**Office Action Summary**

10/519,736

VERTONI, GIOVANNI

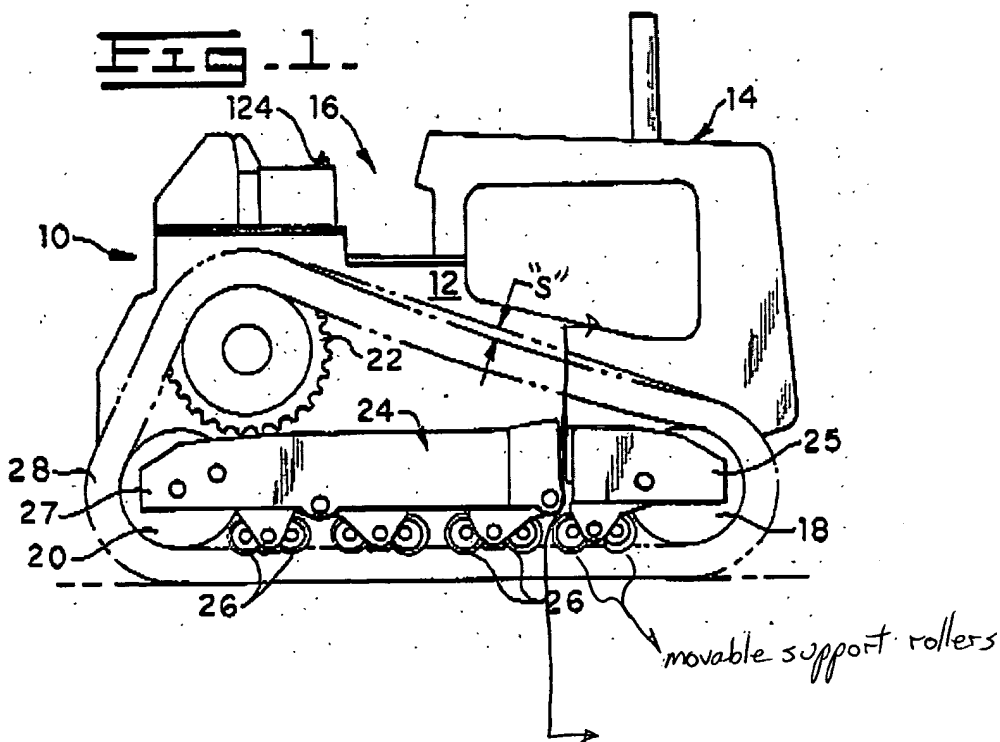
7. Claims 1-2, 4-5, and 7-10 are rejected under 35 U.S.C. 102(b) as being anticipated by Adams et al. As best understood, Adams et al shows a track-tightening device for a crawler assembly. An undercarriage or bogie structure 24 includes elements for carrying a plurality of fixed lower supporting rollers 26, and an idler "back-pull" wheel 20. The structure 24 includes a housing guide system (namely the interaction of the structure 24 and the recoil assembly 30 as shown in Figure 2) for controlled axial sliding of the track-tightening device 30, which is carried by a second

movable structure 25. The structure 24 is box shaped. The second movable structure 25 includes fittings (namely the walls of cylinder 36) to interconnect with the guide system. The second movable structure 25 includes an idler wheel 18 and at least one movable supporting roller (unlabelled), and movably interacts with the structure 24 to modify the wheelbase between the idler wheel 18 and idler "pull-back" wheel 20 through axial sliding.

The supporting roller of the second movably structure 25 is capable of following the longitudinal movement of the idler wheel 18, so that the roller is in constant "contact" with the idler wheel 18, and thus the distance therebetween does not vary during the operating life of the vehicle under any operating condition or in any range of the tightening device 30. The second movable structure 25 carries two or more movable supporting rollers (as seen in Figure 1). The idler wheel 18 is a front wheel. The movably supporting rollers of the second movable structure 25 have the same dimensions and structure as that of the fixed lower supporting rollers 26.

The track-tightening device 30 is a tightener/shock absorber group having a helicoidal spring 42, which operates in extension, and a chamber 34 filled with injection lubricant. The device 30 acts as an adjustable run end and tightener of the track 28. Calibration means 32 adjusts the longitudinal position of a fixed shoulder 40 of the spring 42 with respect to the undercarriage structure 24. The tightener/shock absorber group includes a cylindrical telescopic guide 36 located coaxially with the spring 42 and lubricant injection chamber 34. The spring 42 and injection chamber 34 are separate and arranged in series on a common axis.

The Applicant argues that Adams et al lacks a movable support roller that moves longitudinally with the idler wheel. As shown below, a set of supporting rollers is mounted with the idler wheel 18 on the first end portion 25. Therefore, these supporting rollers would be capable of following the longitudinal movement of the idler wheel 18, and the distance between the supporting rollers and the idler wheel 18 would be constant.
